**PLANNING COMMISSION MEETING AGENDA
NOVEMBER 1, 2022
6:00 PM
DATE: NOVEMBER 1, 2022
LOCATION: CITY HALL, 301 W. CHESTNUT STREET
COMMITTEE SESSIONS: 5:30 PM
REGULAR SESSION: 6:00 PM
ONLINE VIEWING: [HTTPS://US02WEB.ZOOM.US/J/84195094635](https://us02web.zoom.us/j/84195094635)**

1. **LSDP: Grotto at Osage Creek** A proposal to construct a 130-unit multifamily development on 8.0 acres on the west side of S. 28th Street and south of W. Walnut Street in the C-3 (Neighborhood Commercial) zoning district.
 - *STAFF: Zachery Birdsong*
 - *REPRESENTED BY: Conner Threet, Crafton Tull & Assoc.*
2. **LSDP: Villages at Pinnacle Hills**
A proposed multifamily development with 147 units on 20.6 acres south of W. Perry Road and north of W. Ajax Ave, part of an approved mixed-use DCP.
 - *STAFF: Zachery Birdsong*
 - *REPRESENTED BY: Taylor Lindley, Crafton Tull & Assoc.*

Re: Conditional Approval of Civil Plans
Grotto at Osage Creek

RE: Village at Pinnacle Hills
CTA No. 21106400
Rogers Planning No. PL202200161

Waiver Exhibit

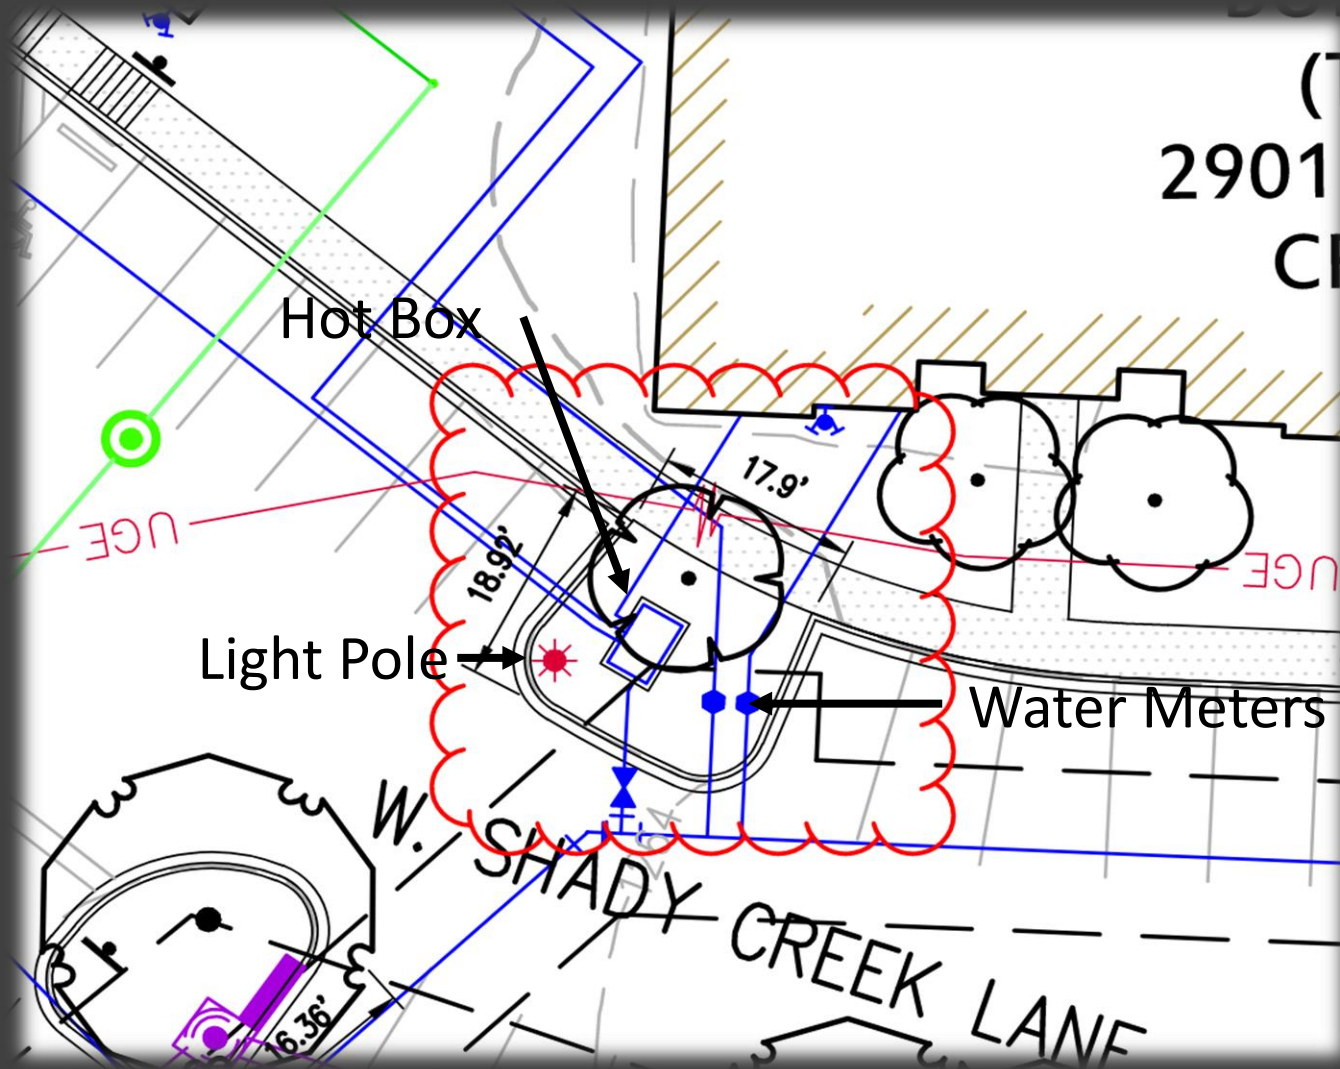
Waiver Request #1

Sec. 14-256(14)(b)(2) requiring deciduous shade trees to be placed on parking lot tree islands.

Stated Hardship

Several utility conflicts prevent planting the required deciduous shade tree. Instead, a smaller ornamental tree is proposed to accommodate utility connections.

Analysis

Staff agrees that due to the conflict it would be inadvisable to plant a deciduous shade tree.

Approve

Waiver Exhibit

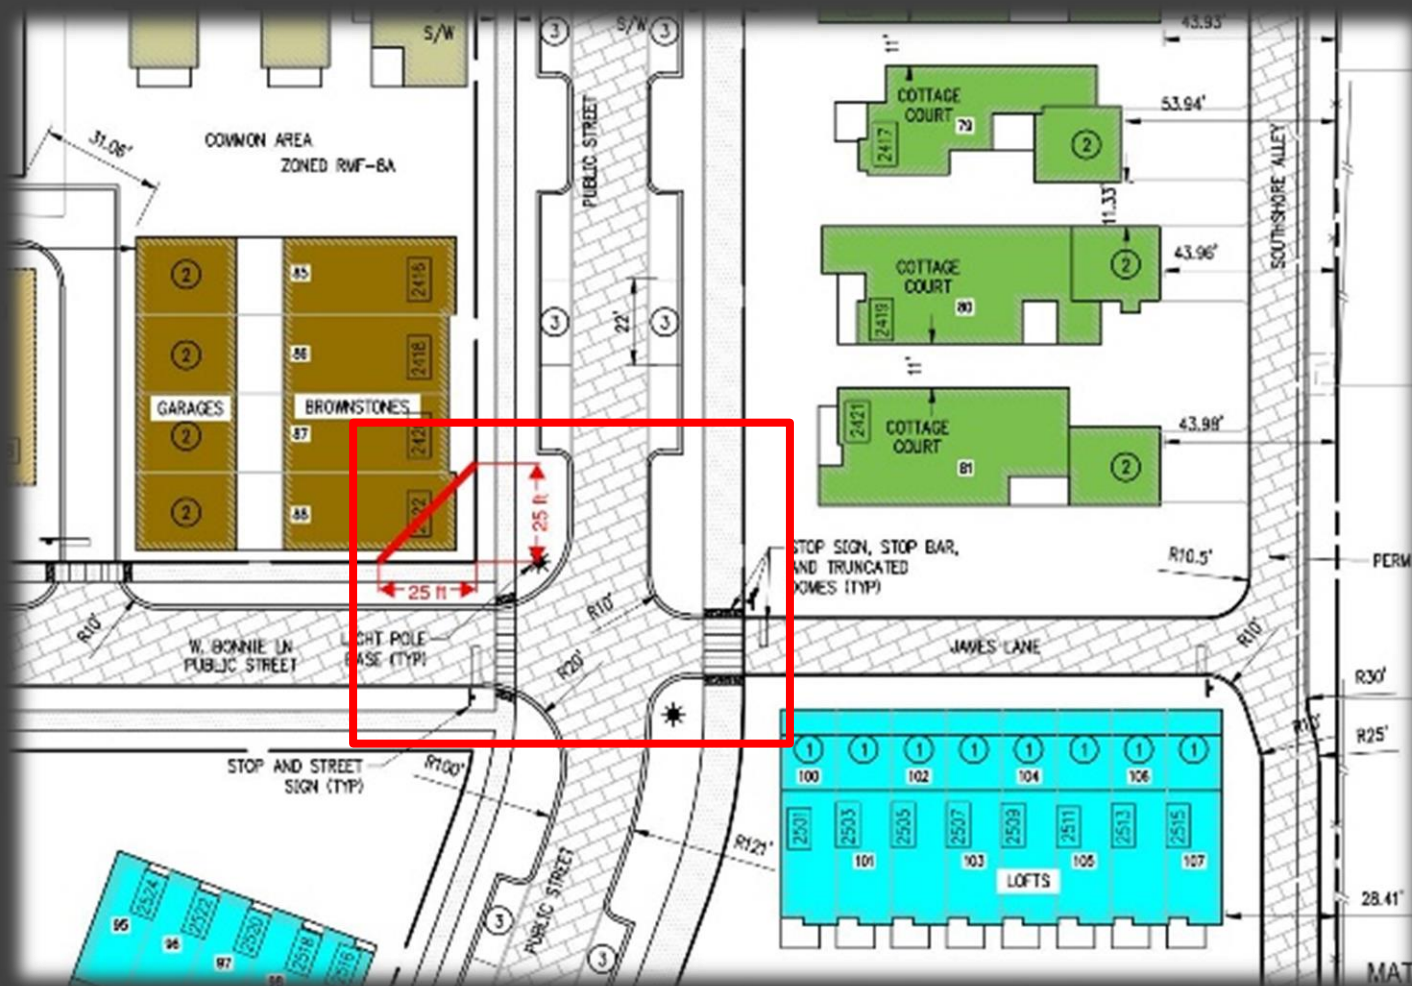
Waiver Request #1

This development was designed to establish an urban feel, with buildings sitting close to the rights-of-way. The applicant states it is not possible to meet the urban design intent and provide the required street trees and other plantings while meeting the sight triangle requirements.

Site Plan

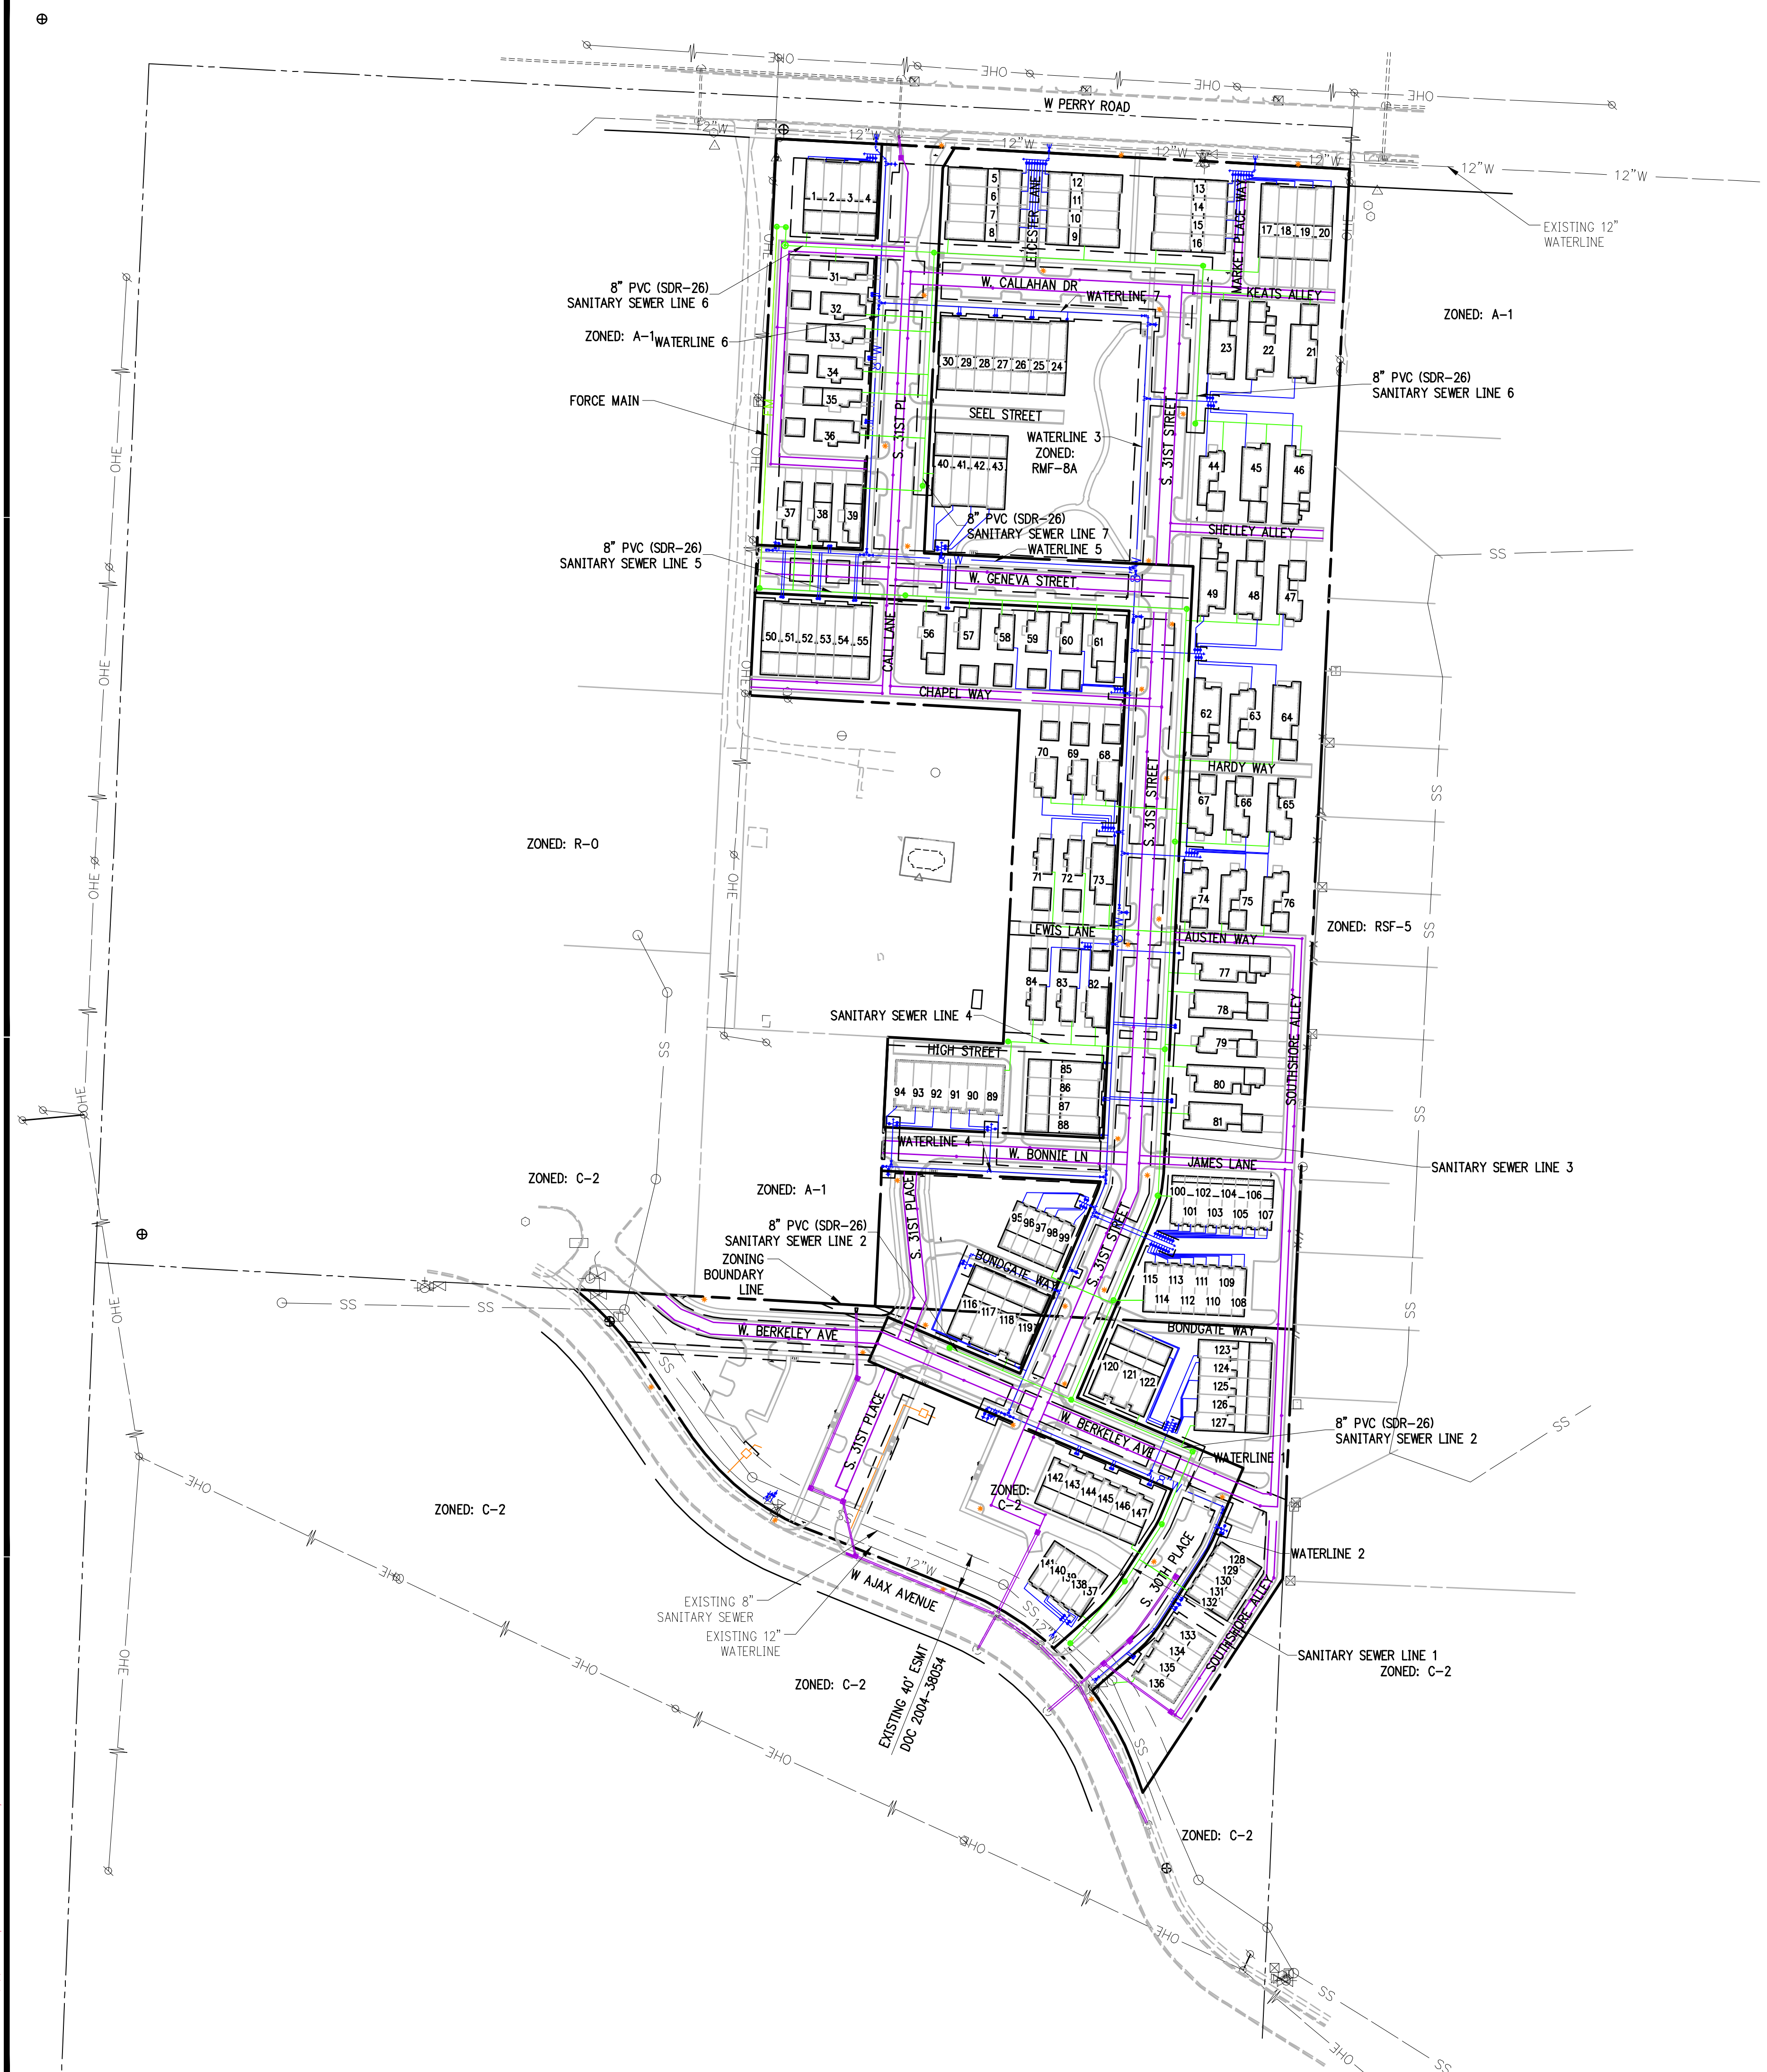
Waivers

1. Approve WAIVER from sight triangle requirements.
2. Deny WAIVER requiring storm pipe velocities to not exceed 12 feet per second.
3. Approve WAIVER requiring minor street connections at intervals not to exceed 660 feet.
